# Memorandum

**Subject:** Ordinance Revising Zoning and other Land Development Regulations Pertaining  
to the Downtown Kendall Urban Center District

ORDINANCE REVISING ZONING AND OTHER LAND DEVELOPMENT REGULATIONS PERTAINING TO THE DOWNTOWN KENDALL URBAN CENTER ZONING DISTRICT ("DKUCD"), AMENDING SECTIONS 33-284.56 THROUGH 33-284.63, CODE OF MIAMI-DADE COUNTY, FLORIDA, PROVIDING SEVERABILITY, INCLUSION IN THE CODE AND AN EFFECTIVE DATE

**Center Sub-District – “B” Street**

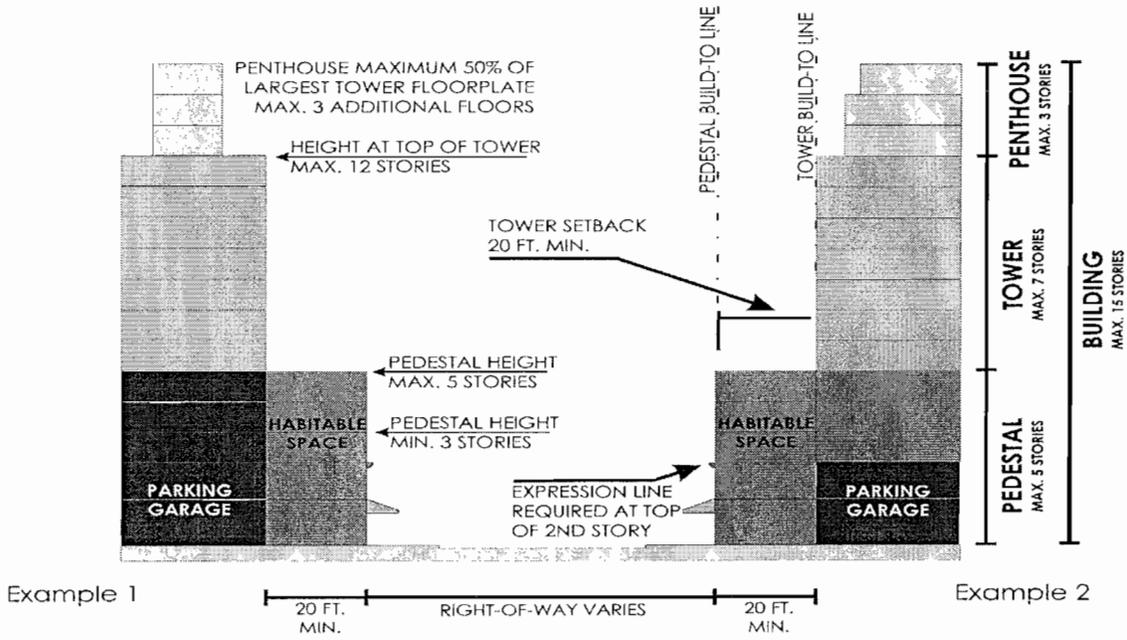
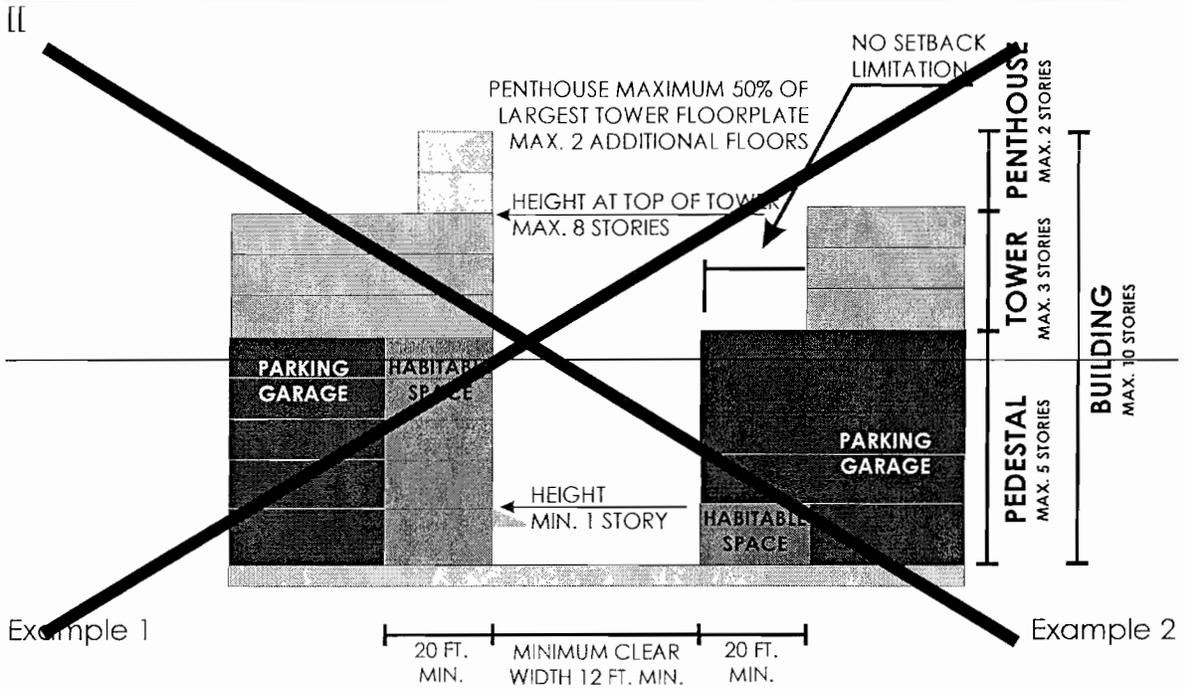
**Building Height** Pedestal – At street front three (3) stories minimum / five (5) stories maximum.  
 Tower – ~~[[Three (3)]]~~ >> Seven (7) << stories maximum.  
 Penthouse – ~~[[Two (2)]]~~ >> Three (3) << stories maximum. Floorplate maximum is fifty (50) percent of largest tower floorplate below.

Center Sub-District – “C” Street

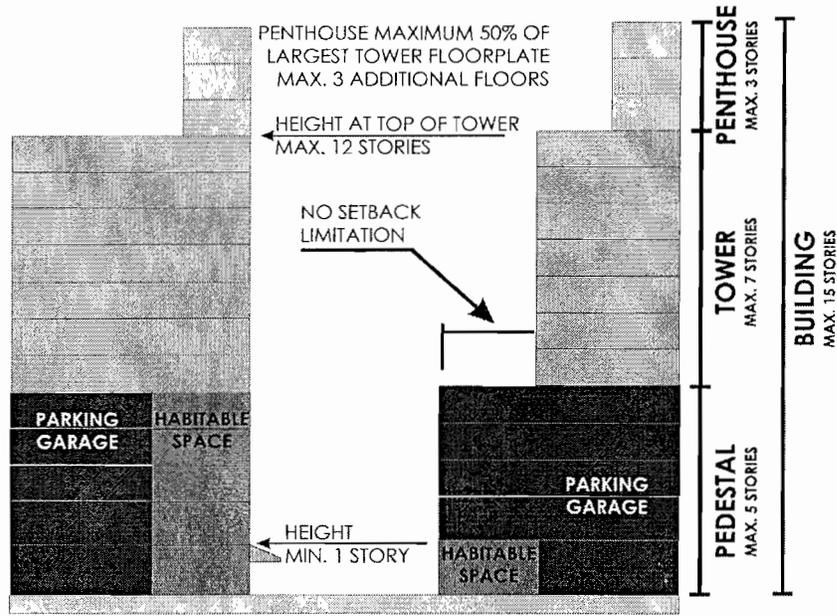
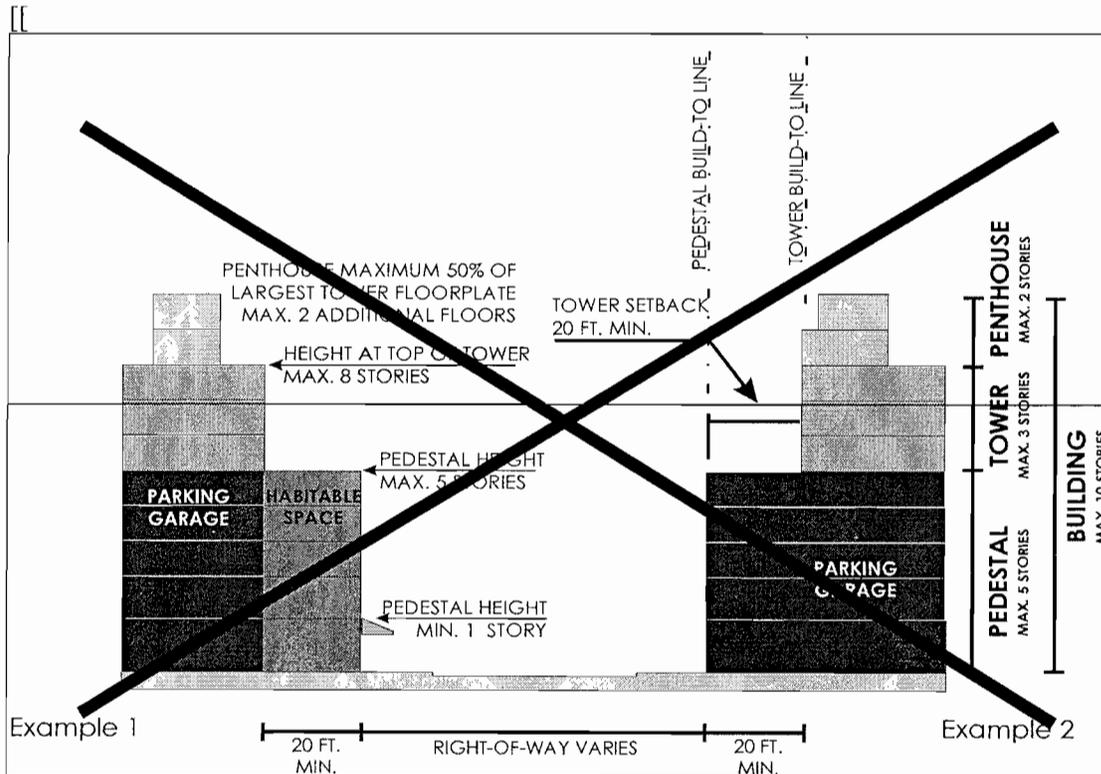
**Building Height** Pedestal – At street front one (1) story minimum/ five (5) stories maximum .  
Tower – ~~Three (3)~~ Seven (7) stories maximum.

**Penthouse** – ~~[[Two (2)]]~~ >> Three (3) << stories maximum. Floorplate maximum is fifty (50) percent of largest tower floorplate below.

**Interior Side / Rear** – ~~[[Thirty (30)]]~~ >> Zero (0) << foot minimum setback for >>pedestal,<< tower and penthouse.

**Center Sub-District – “D” Street**

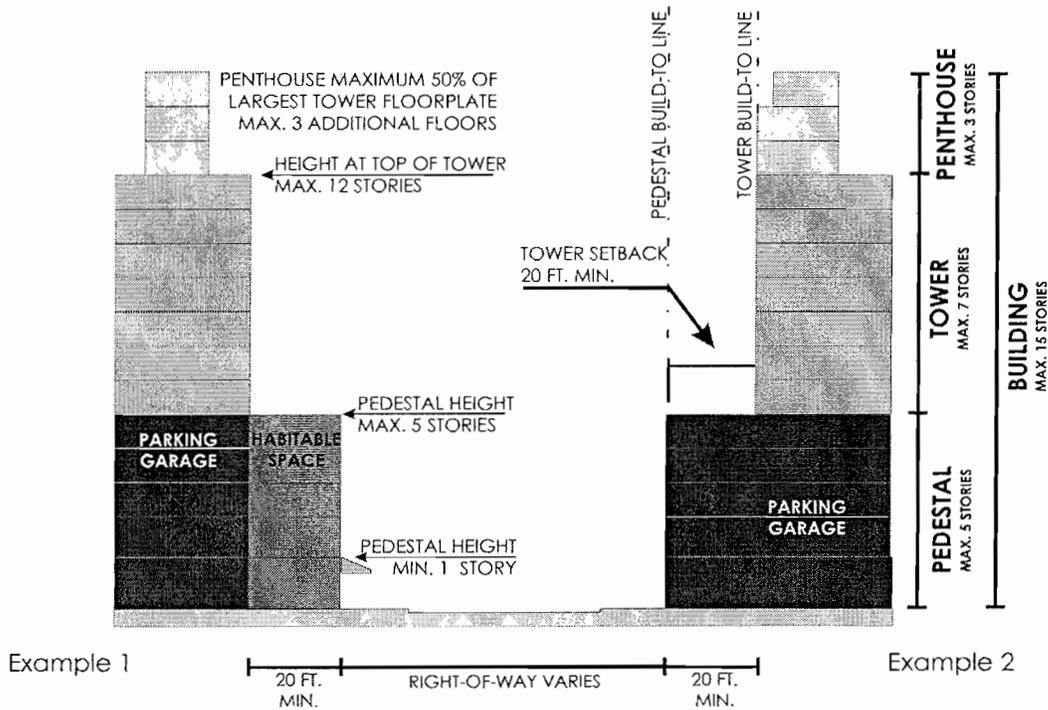
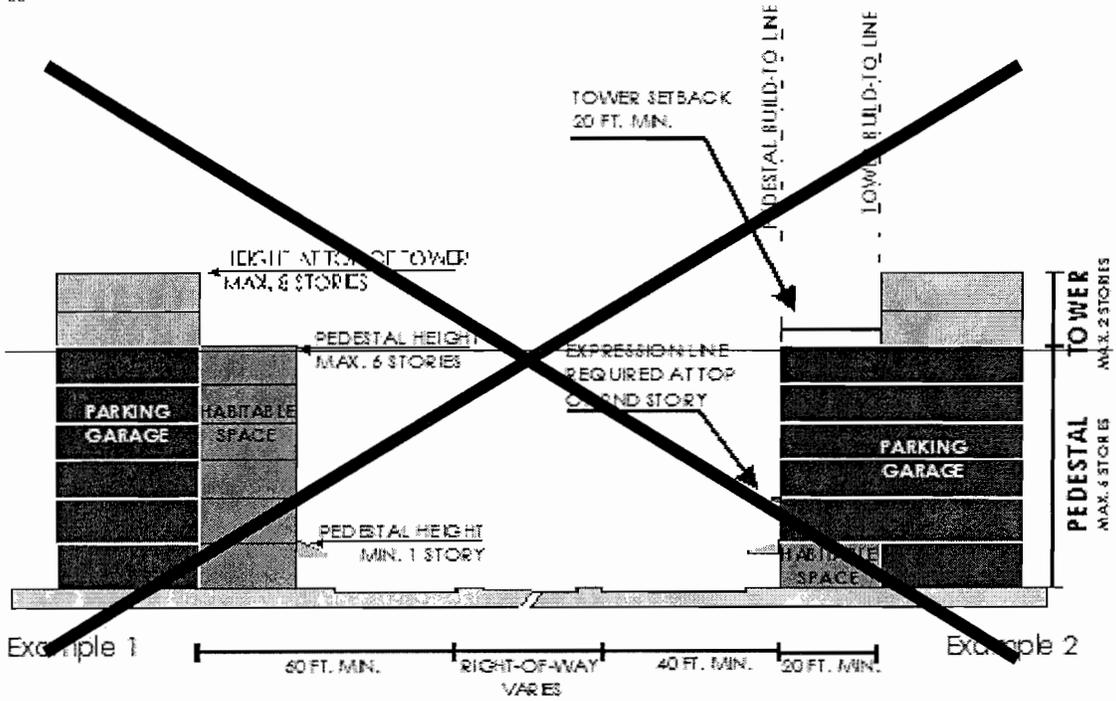
**Building Height**  
**Pedestal** – At street front one (1) story minimum / five (5) stories maximum.  
**Tower** – ~~[[Three (3)]]~~ >> Seven (7) << stories maximum.  
**Penthouse** – ~~[[Two (2)]]~~ >> Three (3) << stories ~~[[additional]]~~ maximum. Floorplate maximum is fifty (50) percent of largest tower floorplate below.

Center Sub-District – “E” Street

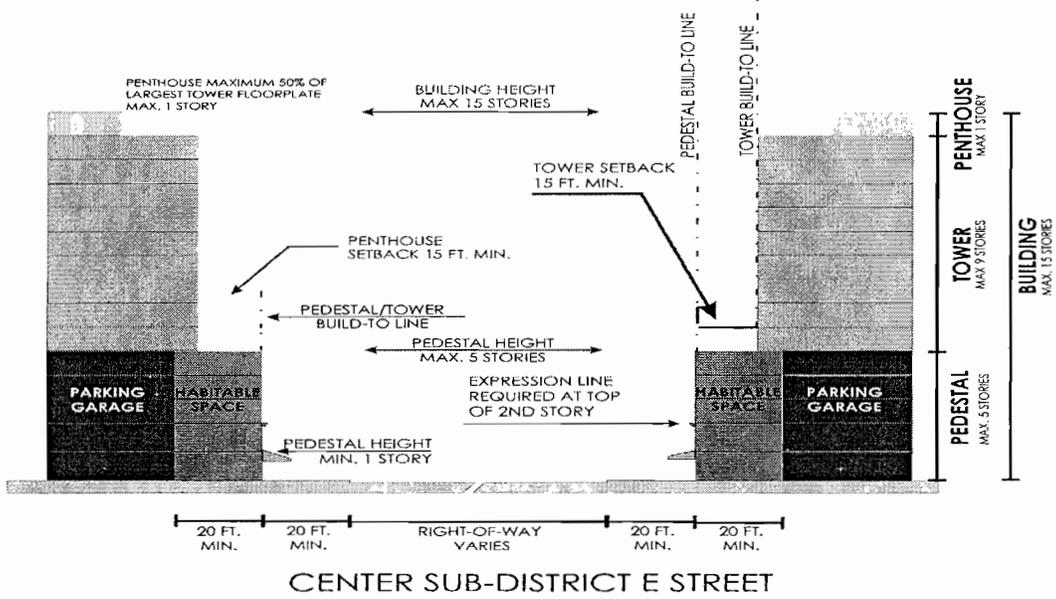
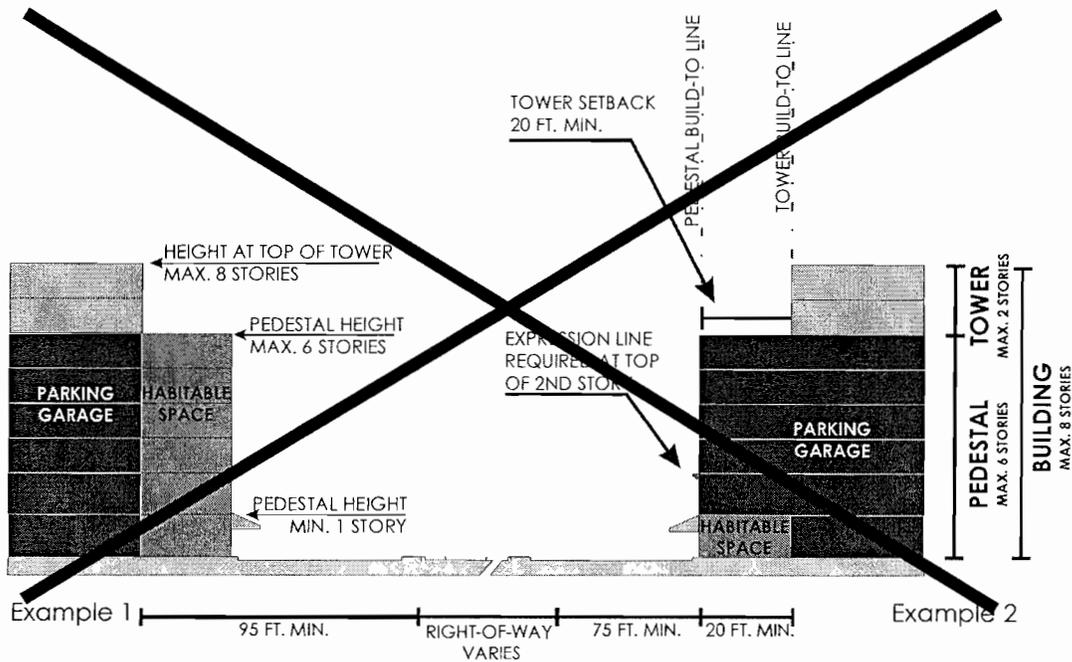
**Building Height**     **Pedestal** – At street front one (1) story minimum / ~~[[six (6)]]~~ >>five (5)<< stories maximum.  
**Tower** – ~~[[Two (2)]]~~ >>Nine (9)<< stories maximum.  
>>Penthouse – One (1) Story.<<

**Front** – Build-to line ~~[[forty (40)]]~~ >>twenty (20)<< feet from right-of way for pedestal/~~[[sixty (60) foot]]~~ >>thirty-five (35) feet<< minimum setback from right-of-way for tower >>and penthouse<<.

**Interior Side / Rear** – ~~[[Twenty (20)]]~~ >>Zero (0)<< foot >>minimum<< setback for pedestal ~~[[/ thirty (30) foot minimum setback for]]~~ >>\_1<< tower >>and penthouse.

**Off-Street Parking**     **Street Level** – ~~[[Eight (8)]]~~ >>Twenty (20)<< foot minimum setback from the front property line.

Edge Sub-District – “E” Street

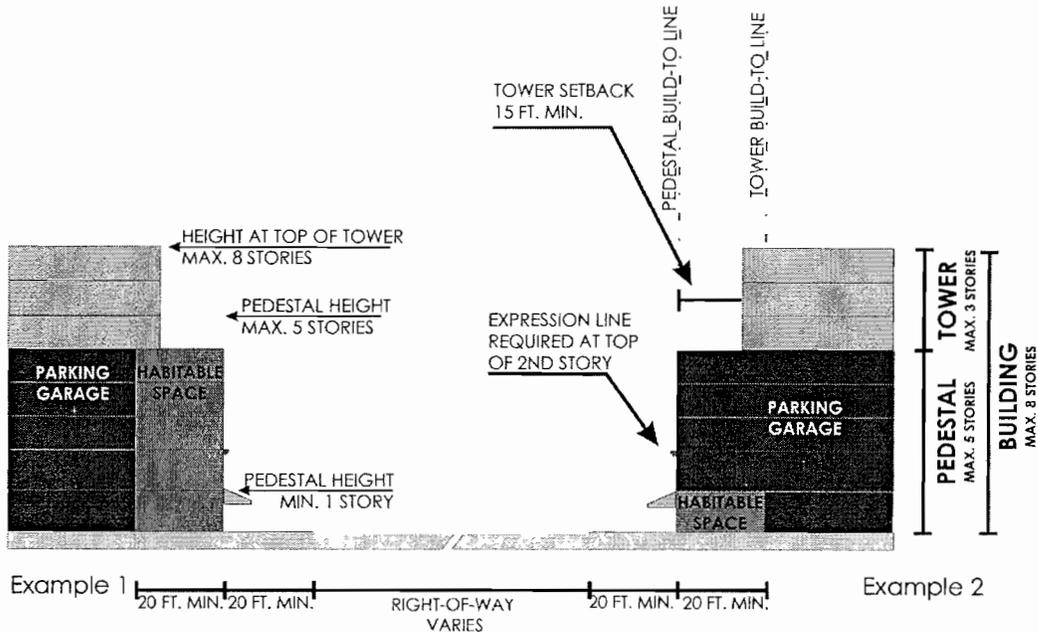
**Front** – Build-to line ~~[[seventy-five (75)]]~~ >>twenty (20)<< feet from right-of-way for pedestal/~~[[ninety]]~~>>thirty<<-five ~~[[95-foot]]~~ >>(35) feet<< minimum setback from right-of-way for tower.

**Interior Side/Rear** – ~~[[Twenty (20) feet]]~~ >>Zero (0) foot<< minimum setback for pedestal ~~[[thirty (30) foot minimum setback for]]~~ >>and<< tower.

**Off-Street Parking**    **Street Level** – ~~[[Eight (8) foot]]~~ >>Twenty (20) feet<< minimum setback from the front of the property line.
